MEMORANDUM

SUBJECT: Work Session on Patrick Henry Library and Parking Garage

On September 1, 2022, the Board of Architectural Review (BAR) held a work session to hear a presentation from Fairfax County staff on the draft Concept Design for the new Patrick Henry Library and Parking Garage. Also in attendance were the two lead architects from RRMM Architects, the firm hired by the County to design the building. There was a very active discussion, with many questions and comments. Though no BAR vote was taken that would reflect a unified position, this memorandum provides comments of BAR members made to Fairfax County staff and RRMM. We would like to share these comments with you, for your deliberations.

Diagrammatic Streetscape Plan Studies: 1/4" = 1'-0"

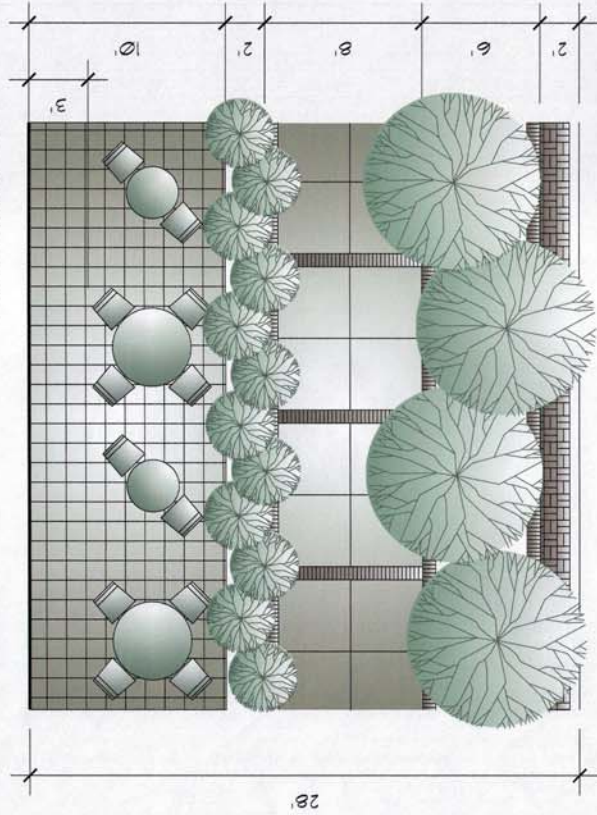
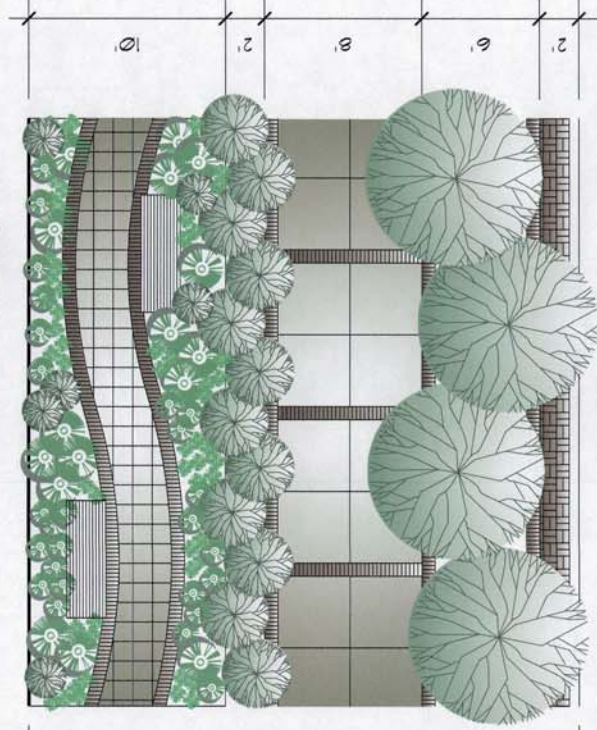
The second attachment consists of two images from a Diagrammatic Streetscape Plan Studies exercise conducted in 2019. They are images that address a line of discussion during the work session, which is the treatment of the sidewalks around the building.

Sloped areas (roofs) may help with garage and, in particular, the stair towers.
Recommend rustification and banding, which will break up the flat monolithic surfaces and add texture and shadowing to an otherwise plain surface.
Wanted to make sure that the signature bricks will remain on sidewalk
Possibly use a brick-banded sidewalk rather than traditional brick sidewalk (difficulty walking on brick sidewalk)
Recommend that the sidewalk be done in flush dry laid bricks on concrete that will yield a flat surface, rather than using brick and mortar.
Work with DPW - can walking portion of sidewalk be wider? Refer to "Preferred Image" and sidewalk studies (attached)
Emphasize indigenous architectural qualities of Vienna Parking garage doesn't seem to me to be too high, or massive especially since it will be shielded from view on the Maple Ave side by the library building and from Vienna ES side by lots of tall trees. Its impact can be mitigated by more design work
